RE: THOMAS STREET CAR PARK, CHATSWOOD - MP 09_0066 MOD 7

I refer to Willoughby City Council's letter of the 21 May 2013 that responds to our amendments made to the basement car park level. The main issues in Council's letter relate to the separation of the public car park, lift use and Relative Levels. Each of the issues is addressed below.

A-0110

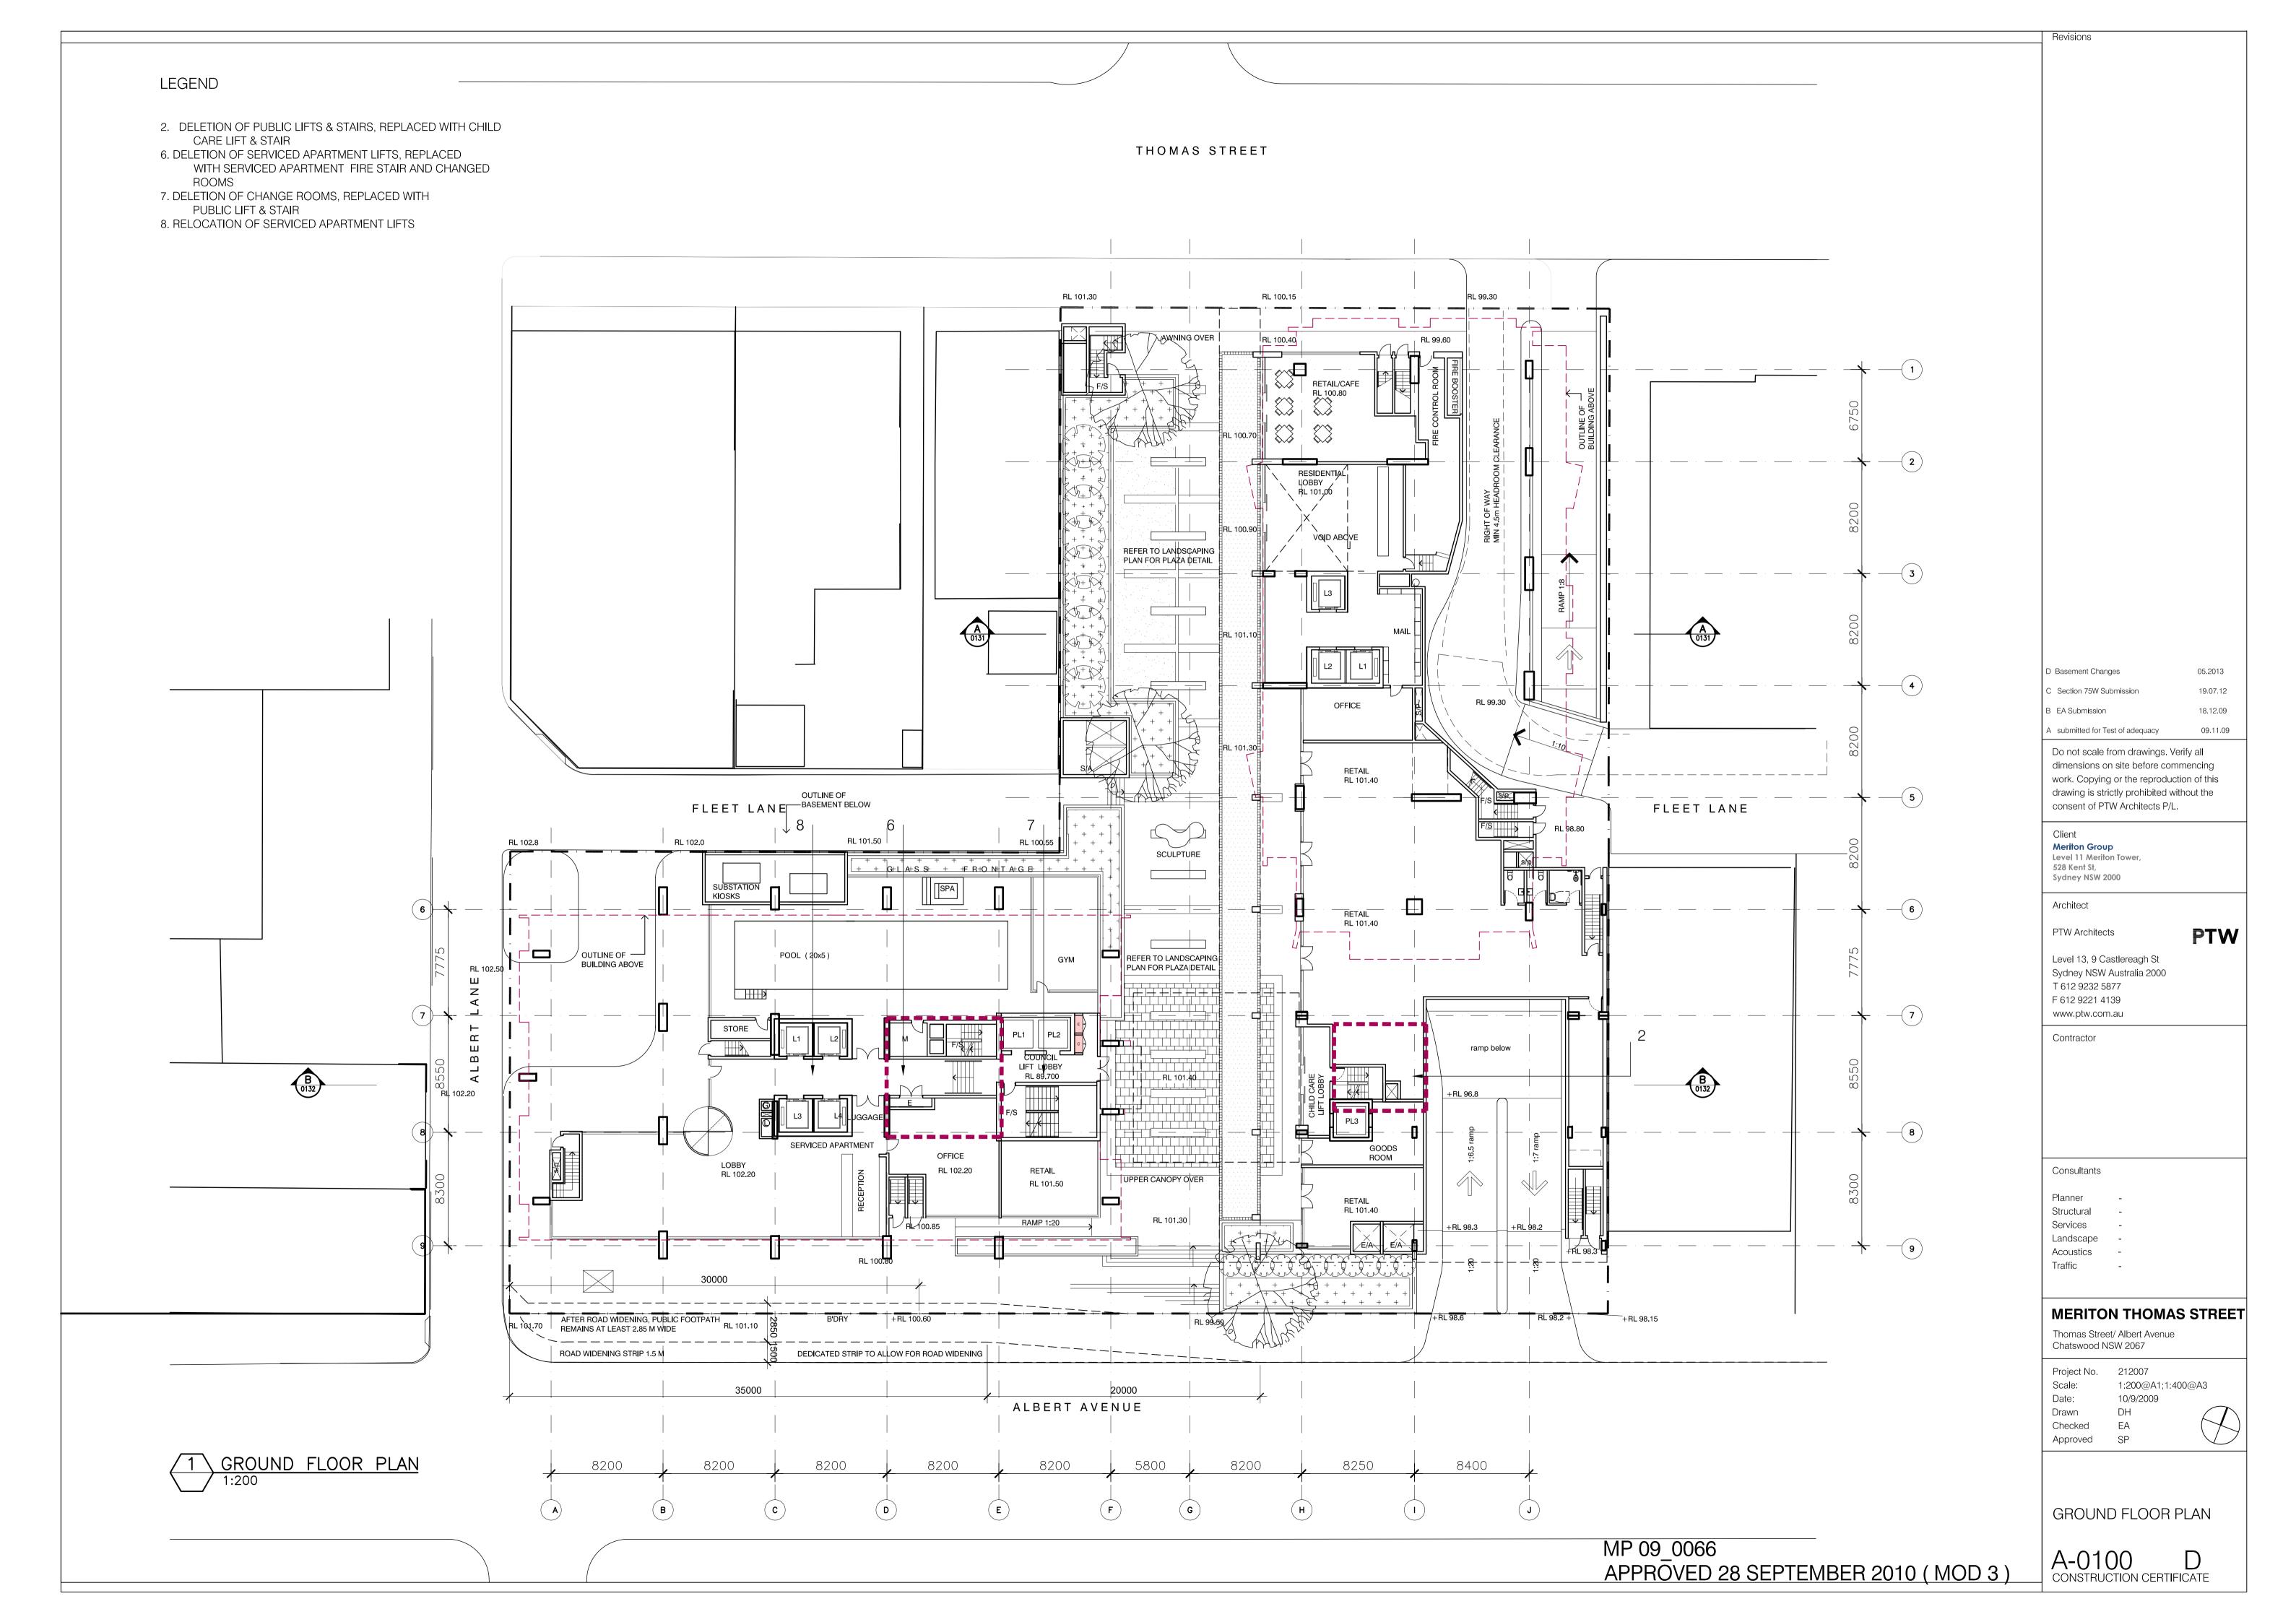
<u>Basement Level 1</u> – a toll barrier will be provided as the main entry into the public car park for complete separation from private uses located in the development.

A-0111 SECTION 75 W SUBMISSION

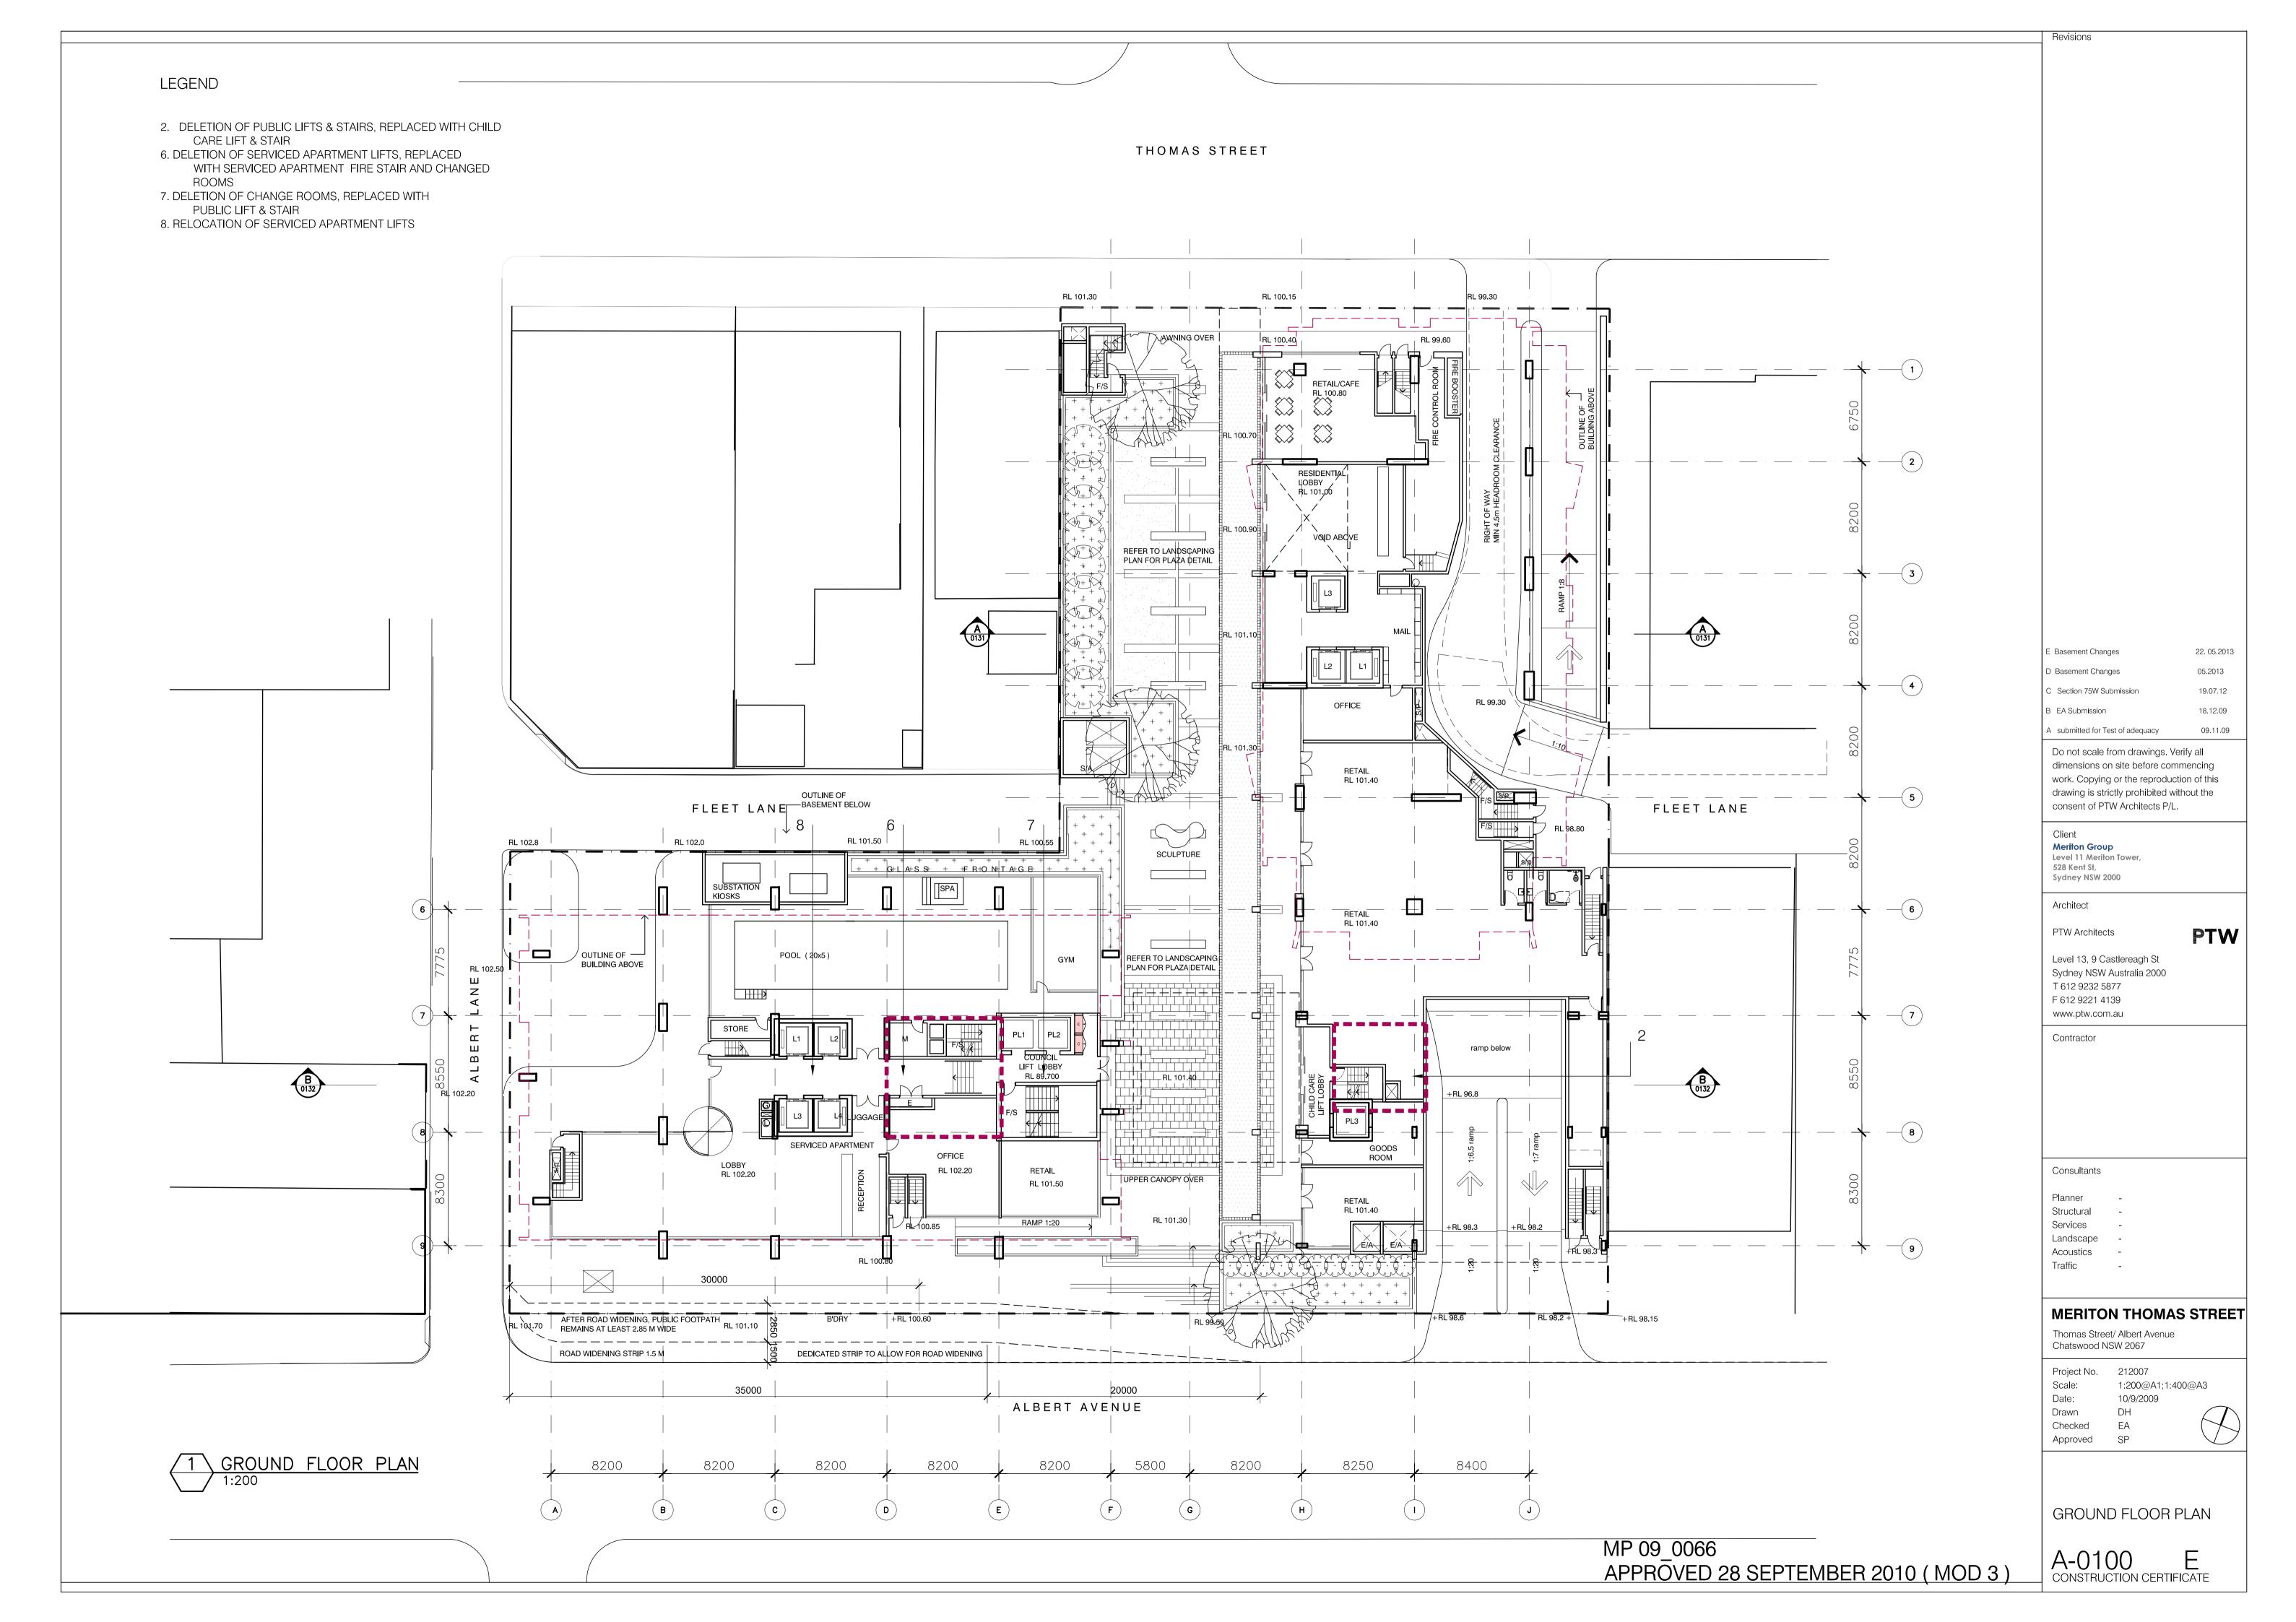
<u>Basement Level 2</u> – new walls are incorporated on the plans at the eastern end of the public car park area to provide complete separation from private use. For this to be achieved, 5 public car parking spaces have been relocated to the northern side of the public car park on Level 1.

A-0112 F
CONSTRUCTION CERTIFICATE

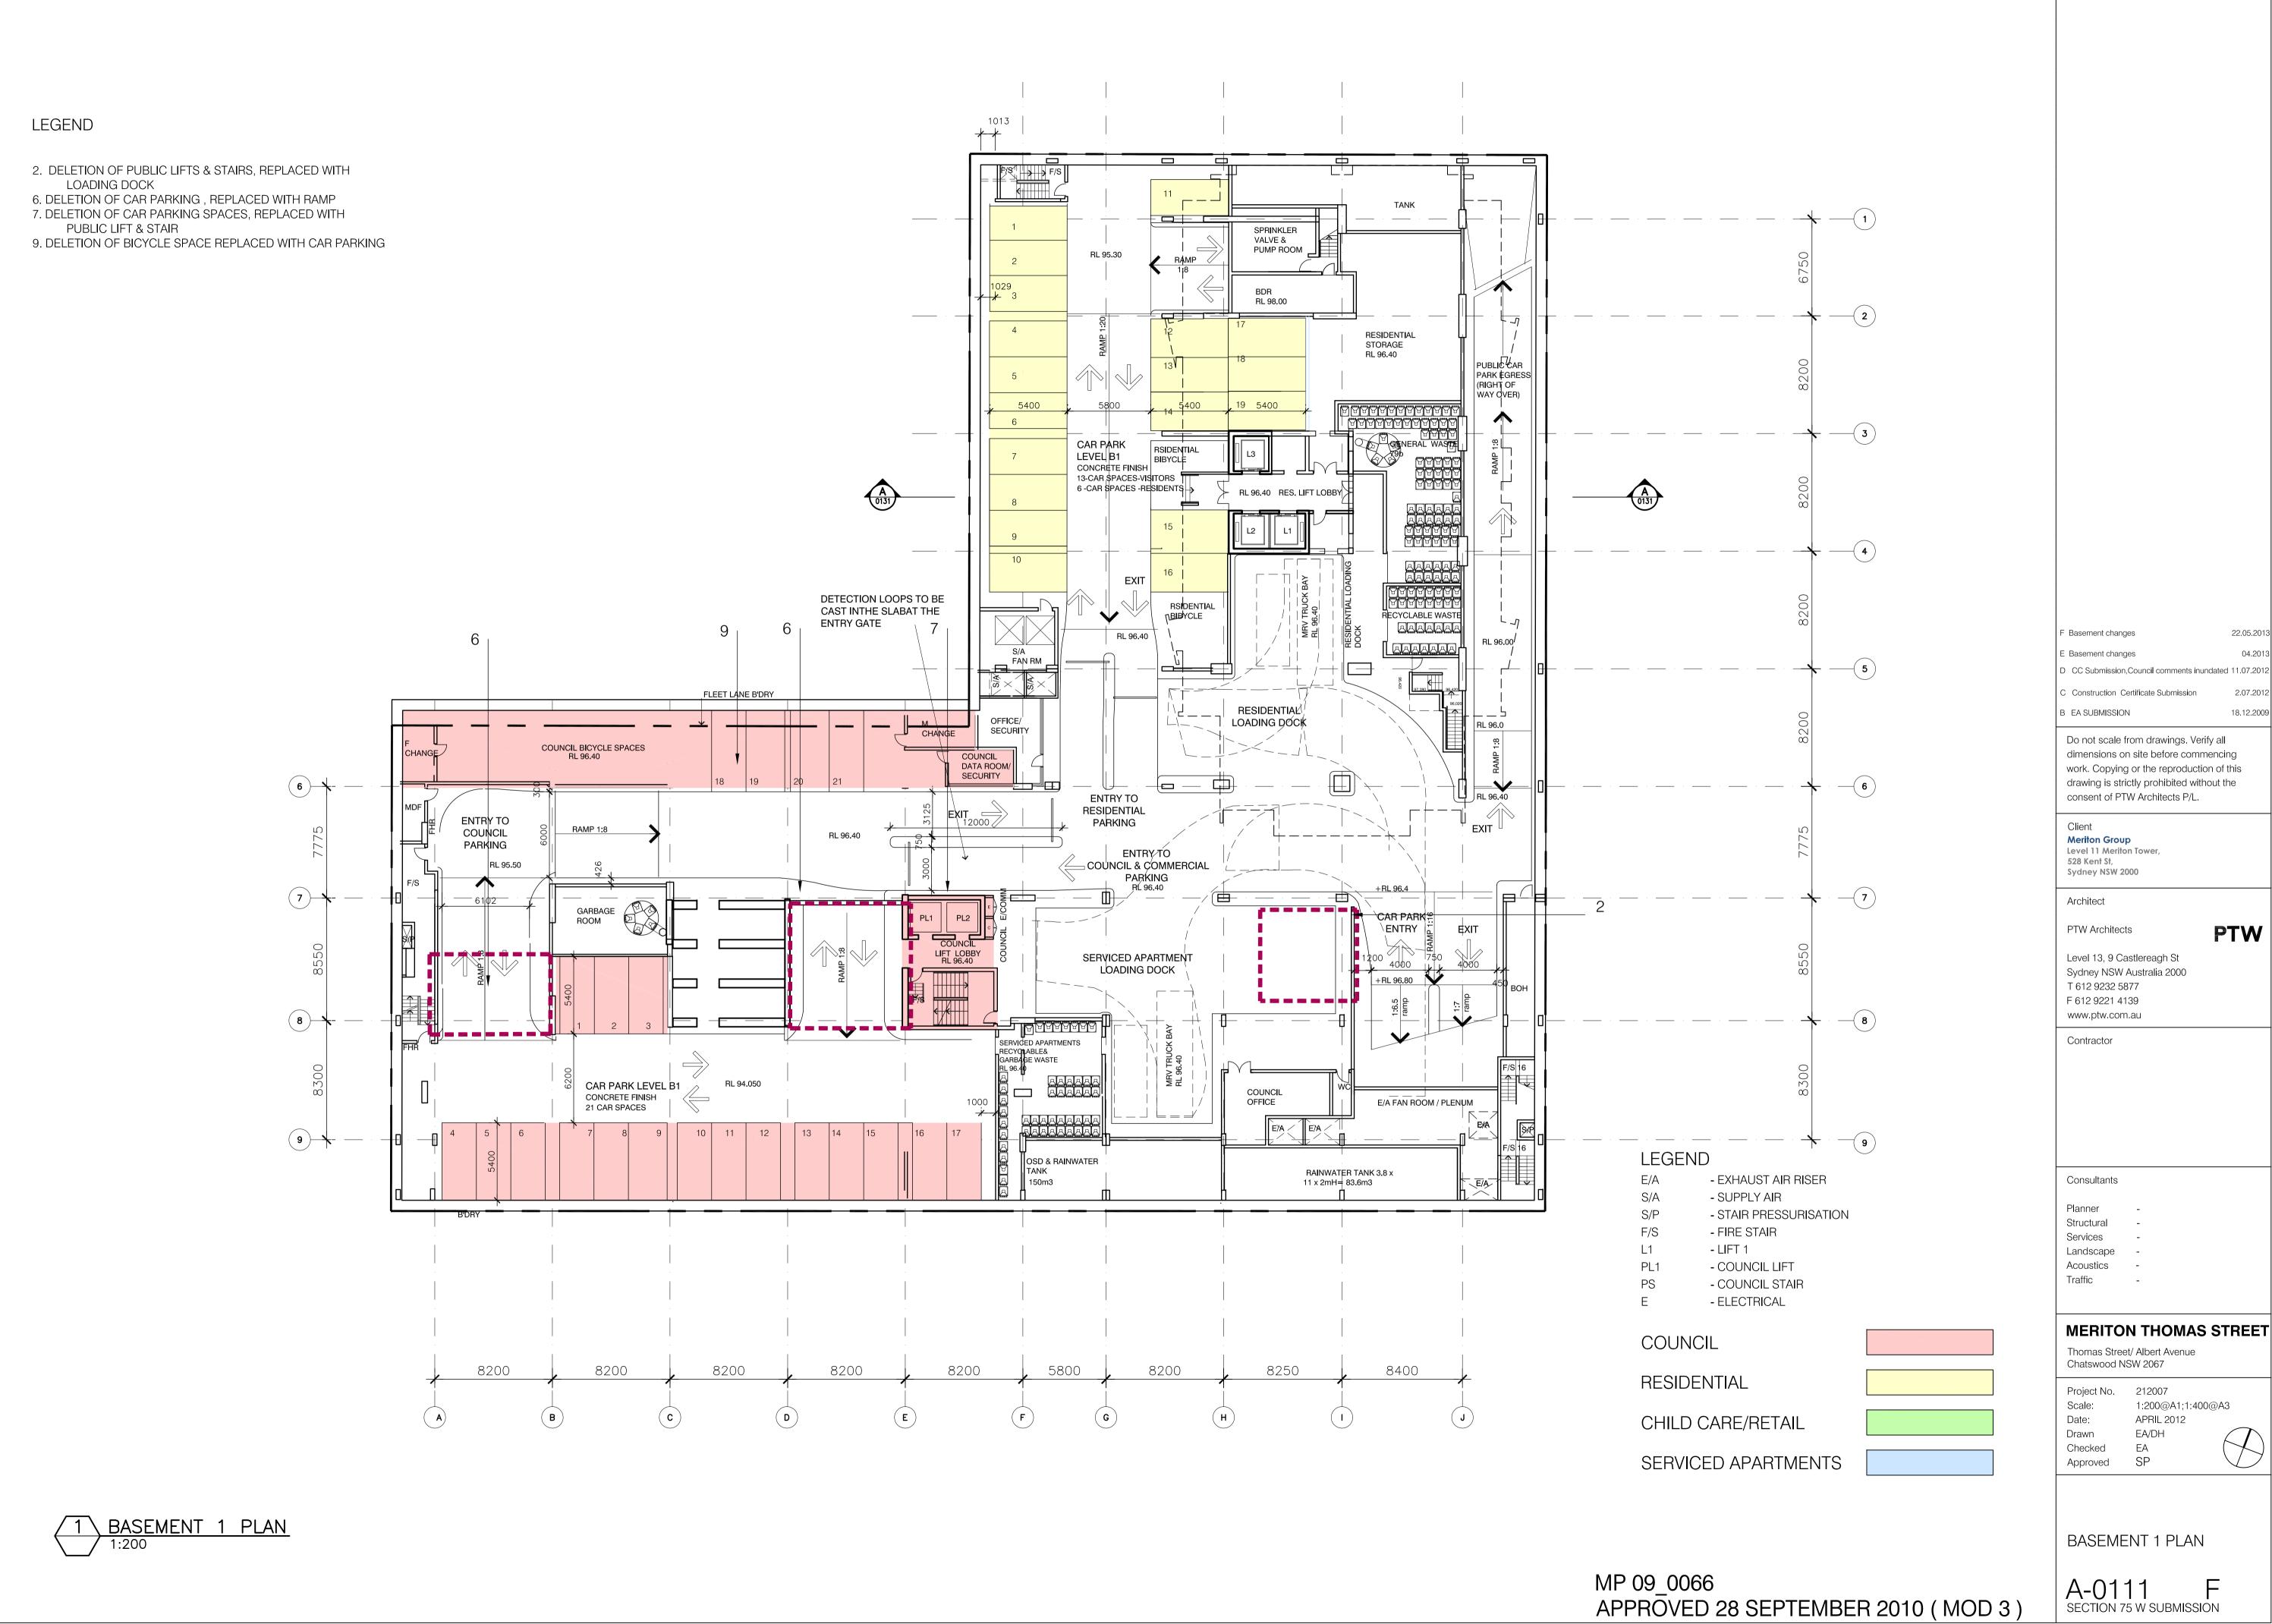
<u>Basement Levels 3, 4 & 5</u> – Walls have been made clearer on the plans that isolate the public car park from any other use.
